CONTEMPORARY FACILITIES
BATOCHÉ NATIONAL HISTORIC SITE

FOR GENERAL DESIGN AND APPEARANCE ONLY		REVISION		DATE		DRW.		APP'D.	
<input checked="" type="checkbox"/> Review Completed	<input type="checkbox"/> Resubmit	<input type="checkbox"/> Make corrections	<input type="checkbox"/> Make corrections						
Contractor is solely responsible for all dimensions and quantities and coordination. This review does not in any way relieve contractor from these responsibilities.									
Per: <i>Y. Yoneda</i> Date: <i>11/19/85</i> File No: <i>85-505</i> Request Mechanical									
Yoneda & Associates Ltd. <i>Regina</i>									
Consulting Professional Engineers

NO.	REVISION	DATE	DRW.	APP'D.
Honeywell				
TITLE CONTEMPORARY FACILITIES BATOCHÉ NATIONAL HISTORIC SITE BATOCHÉ, SASKATCHEWAN				
JOB NAME INTEREST MECHANICAL				
DATE	03/07/85	REF.		
DRWN	CHECKED	APP'D.	DWG. NO.	REV.
MLJG			330663	2/3

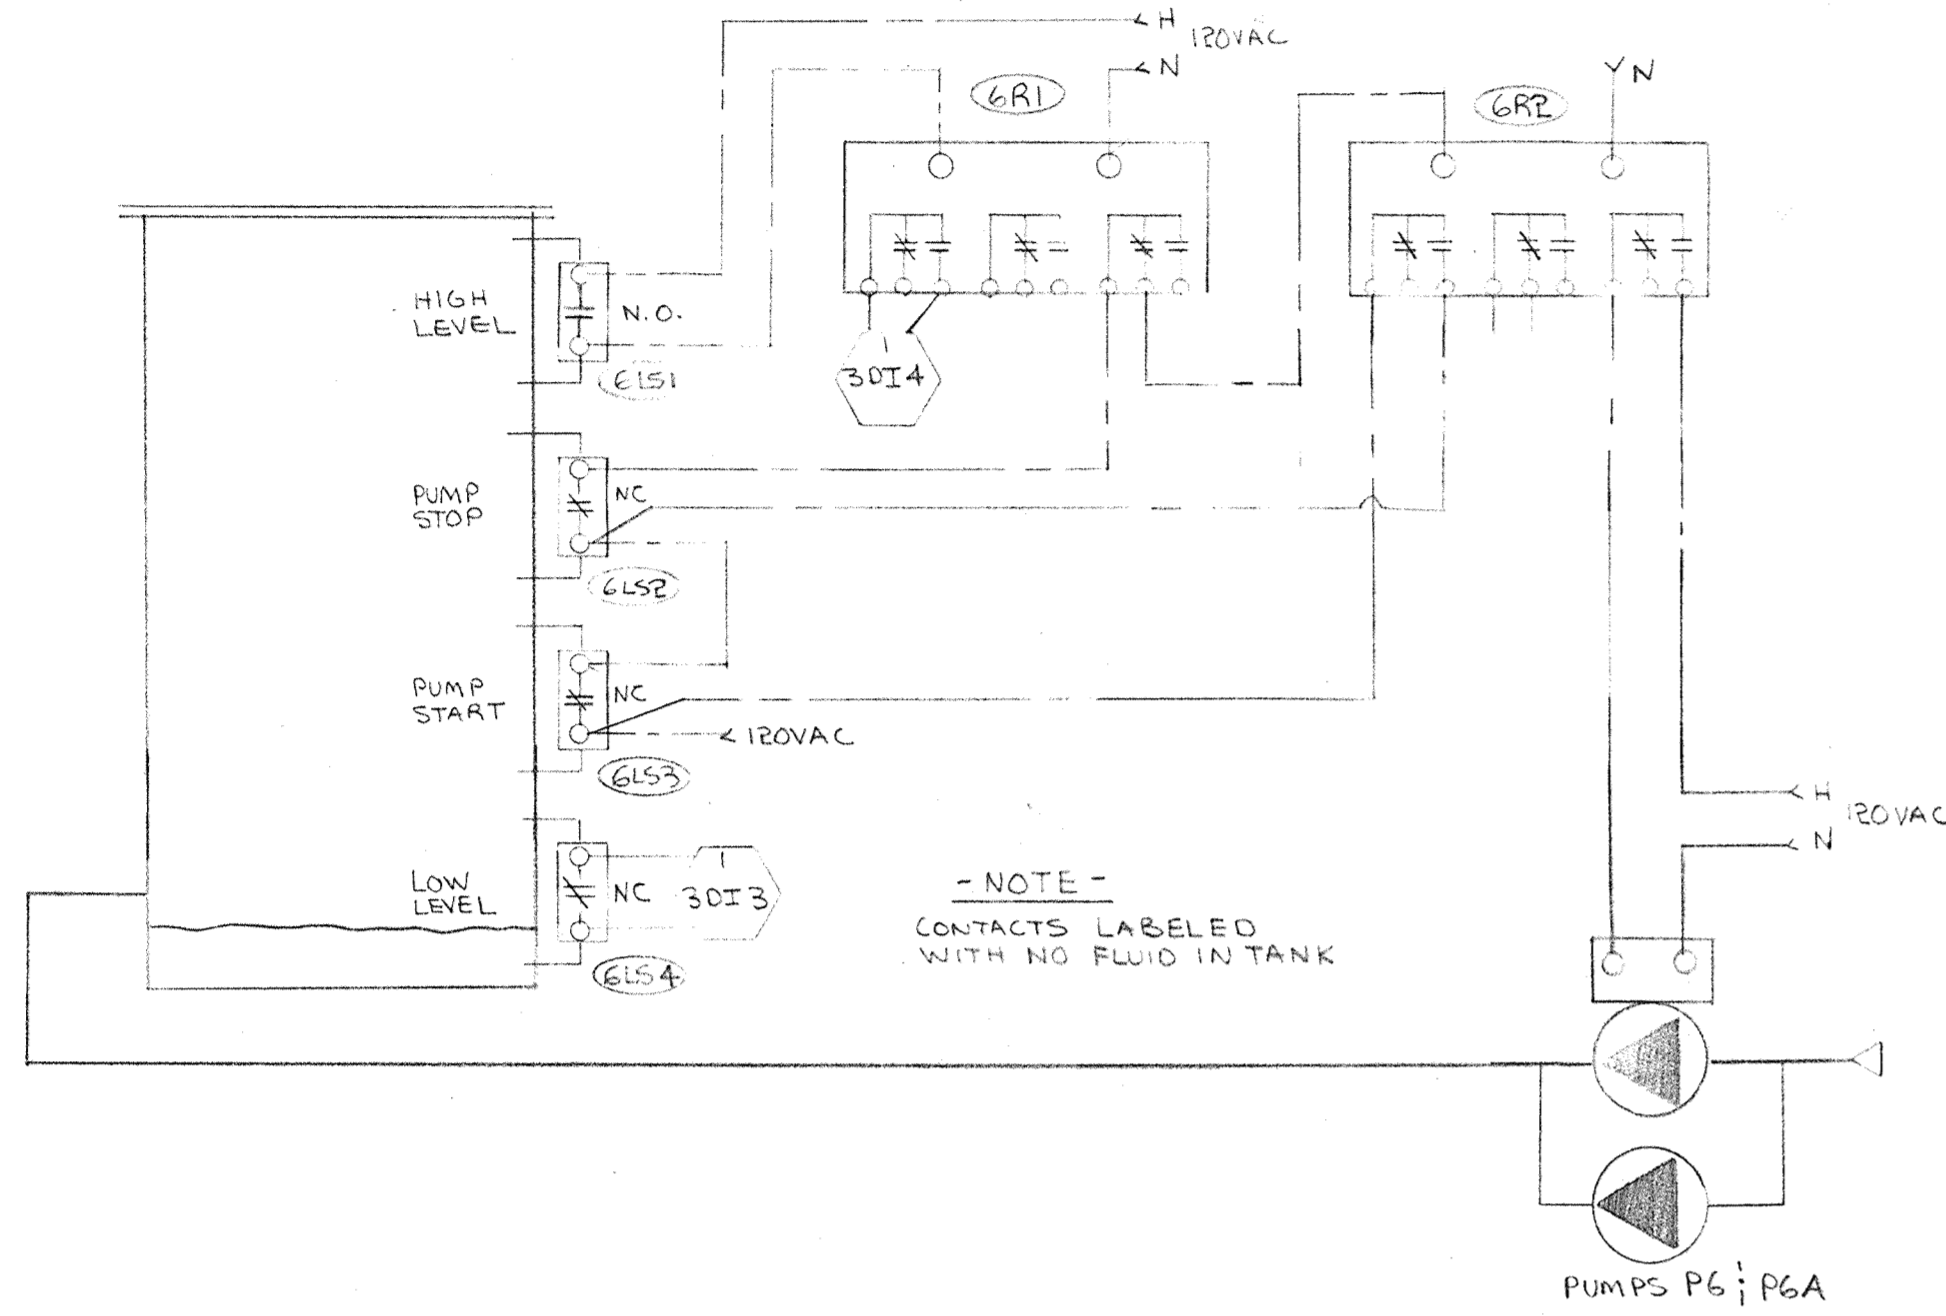
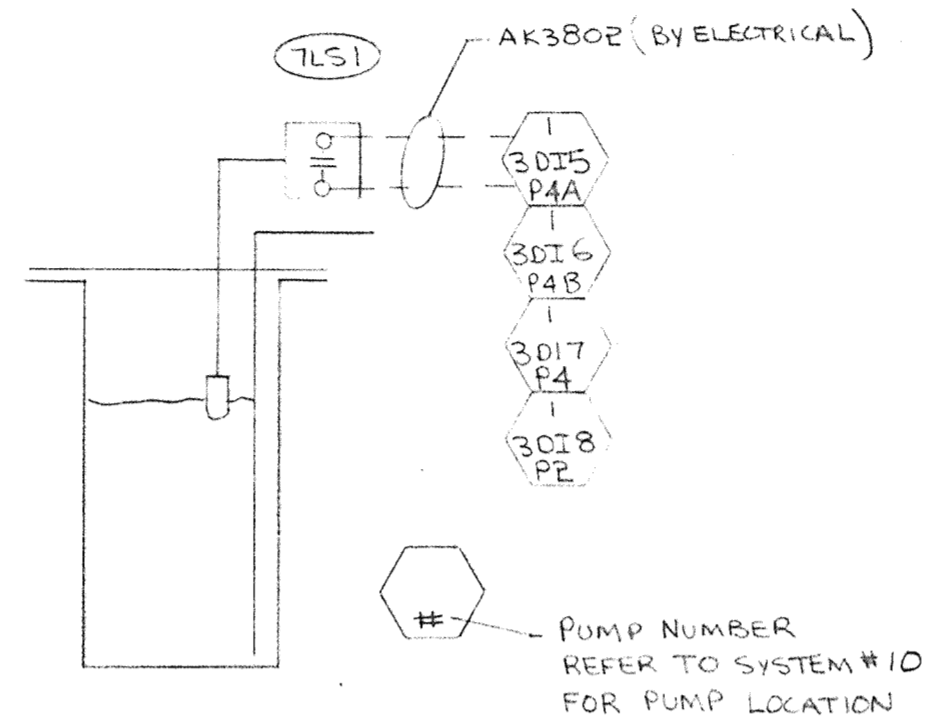
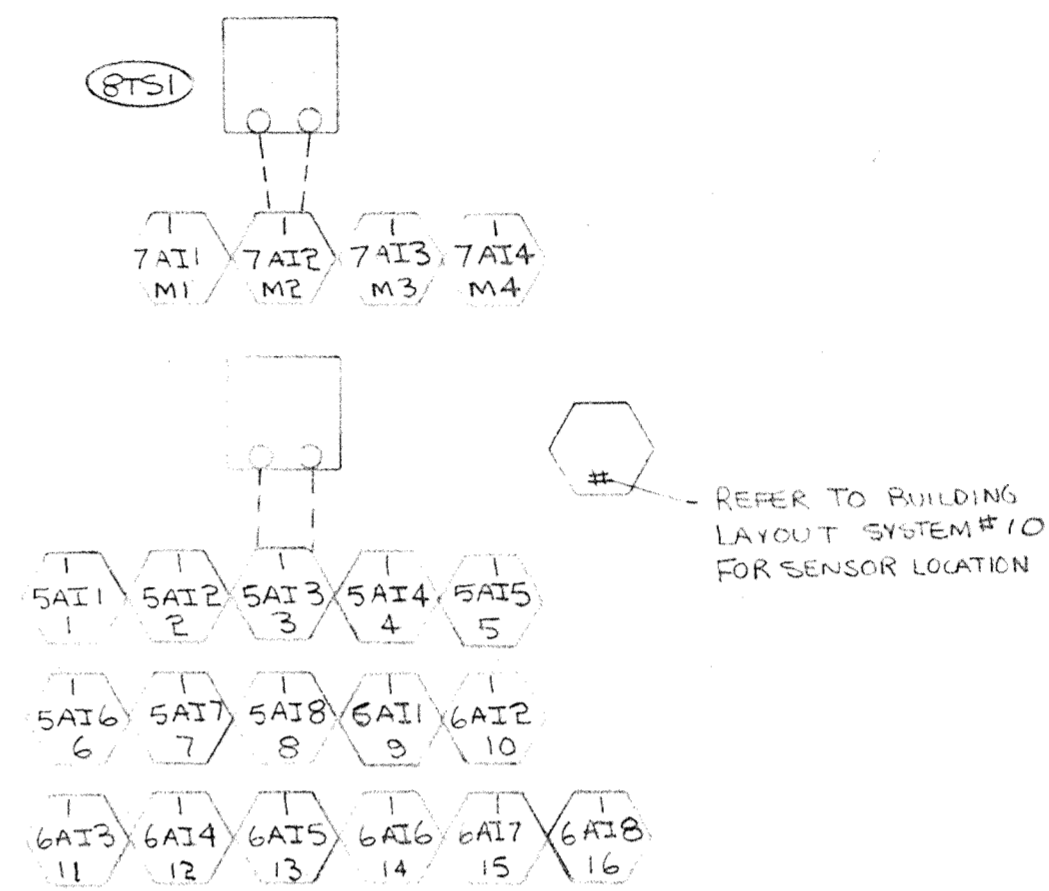
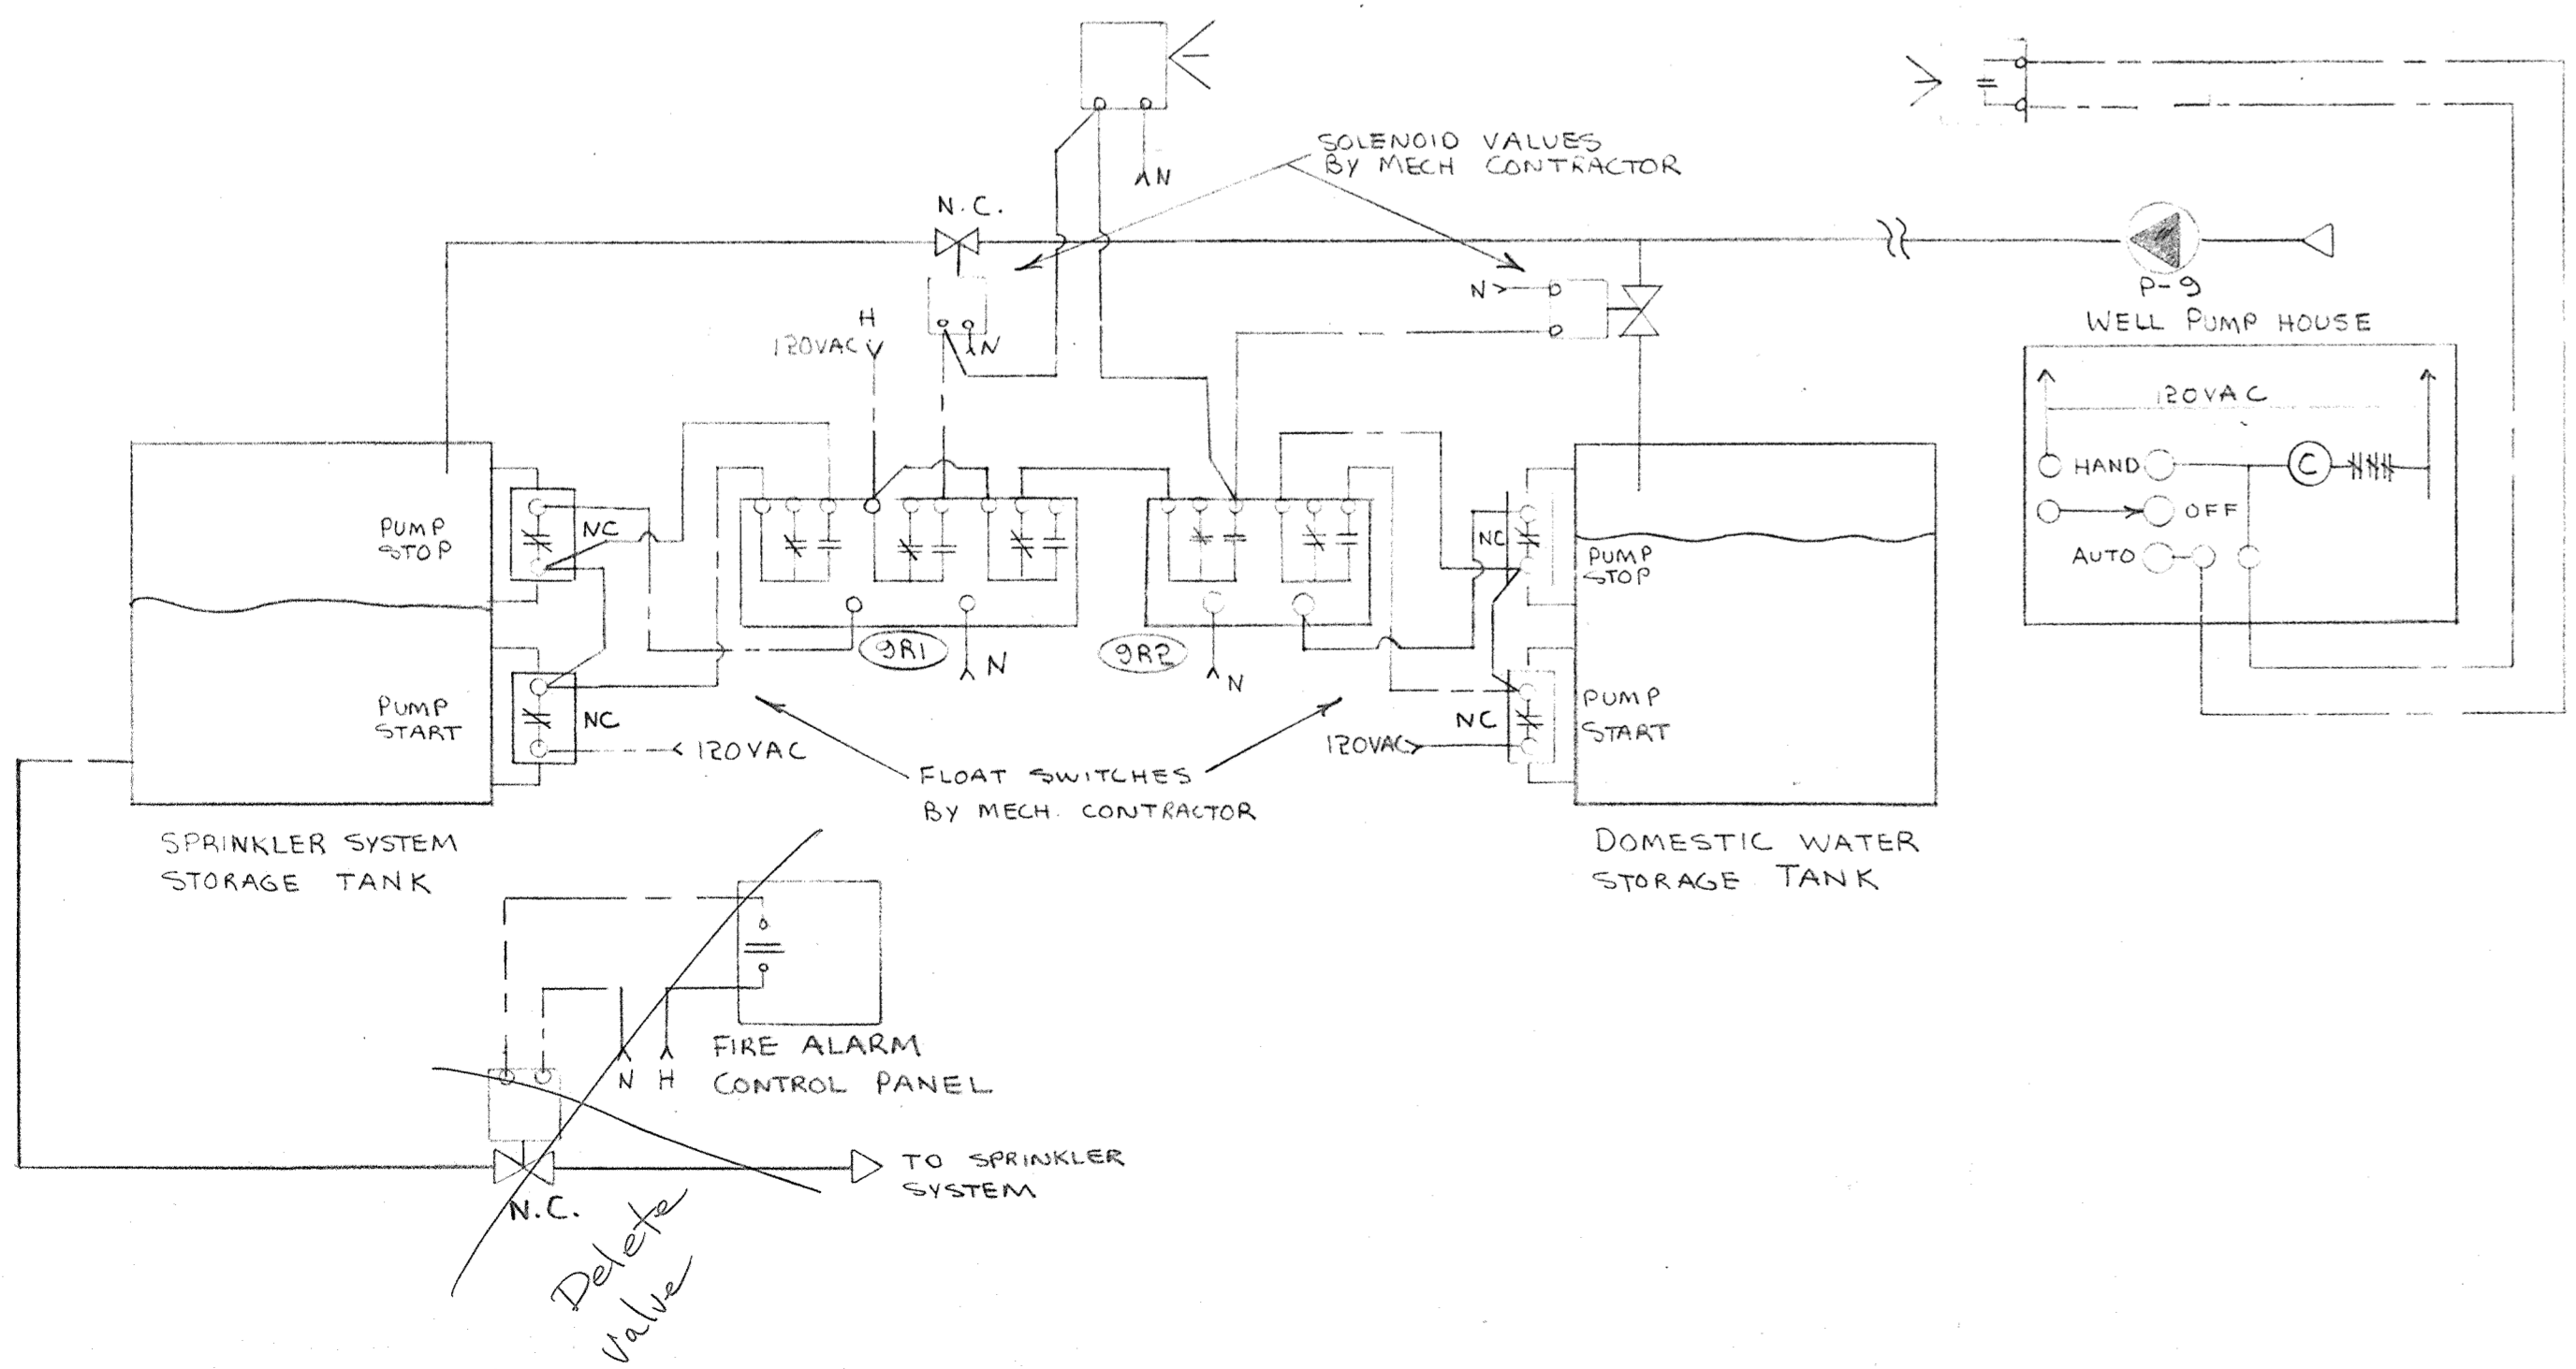
REVIEWED
FOR GENERAL DESIGN AND APPEARANCE ONLY
☒ Review Completed ☐ Rejected
☐ Resubmit ☒ Make corrections Noted
Contractor is solely responsible for all Dimensions, Quantities and Coordination. This review does not in any way relieve contractor from these responsibilities.
Per: *B.L.* Date: *Apr 11* File No: *63-205*
Yoneda & Associates Ltd.
Consulting Professional Engineers — Regina
